SB Number:	SB 2H9-006	Creation Date: 15/09/2010
Subject:	Improving the adhesive material of the pad front SEP	
Model:	FS-1028MFP/DP, FS-1028MFP/3040MFP/3140MFP, FS-C2026MFP/2126MFP, DP-110

Affected models:	DP-110	FS-1028MFP/DP, FS-1028MFP/1128MFP/3040MFP/3140MFP, FS-C2026MFP/2126MFP
------------------	--------	---

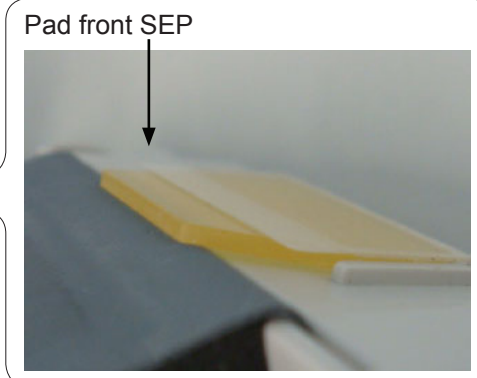
Phenomenon	The pad front SEP may disengage from the paper feed guide (upper guide B) .
Cause	When removing the original to clear a paper jam at the DP, the pad front SEP may peel off.
Solution	To improve the adhesive strength, the material of the double faced tape surface of the pad front SEP has been changed from 5000NS to TW-Y01 type .

Classification	<input type="checkbox"/> Entire stock rework	<input type="checkbox"/> In-field modification at next visit	<input type="checkbox"/> In-field modification by case	<input checked="" type="checkbox"/> No modification necessary
Field measure	When the above mentioned phenomenon occurs, please replace the pad front SEP with the latest type.
